**CENTER FOR DRUG EVALUATION AND
RESEARCH**

212854Orig1s000

Epidemiology: Sufficiency Memo for Using ARIA to Evaluate the Risk of
Needlestick injury Associated with ZIMHI™ use

Drug Name(s): Naloxone HCl injection (ZIMHI™)

Figure 1. Schematic of Applicant’s Proposed Safety Surveillance and Reporting Program*

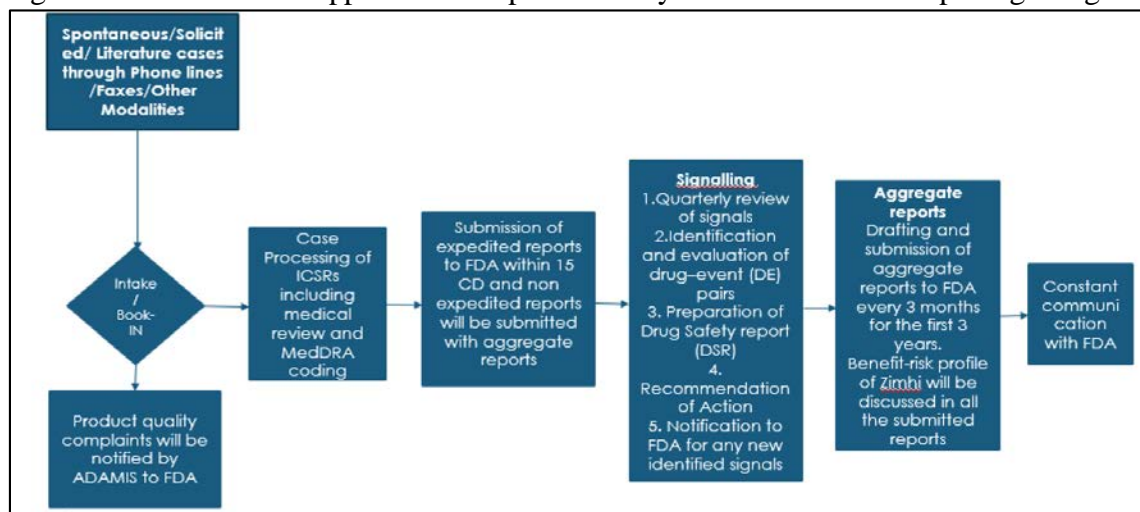
The surveillance plan described by the Applicant appears compliant with FDA regulations and reasonable from a pharmacovigilance perspective. By including reports of needlestick injury and blood-borne infection with expedited reports, the Applicant appears committed to monitoring these events more closely, regardless of whether or not they are described in labeling. That said, a surveillance plan relying exclusively on spontaneous reports to monitor events occurring in the community will almost certainly under-capture events of interest such as needlestick injury. The enhanced training programs offered by the Applicant may to some extent reduce the likelihood of needlestick injury. However, such training will not reduce the risk of such injury among untrained users.

We note the challenges of collecting data on needlestick injury in the context of community use by untrained laypersons, and postmarket surveillance of this potential issue will likely be limited. As such, at this time, we do not have specific suggestions regarding improvements to the surveillance plan proposed by the Applicant.
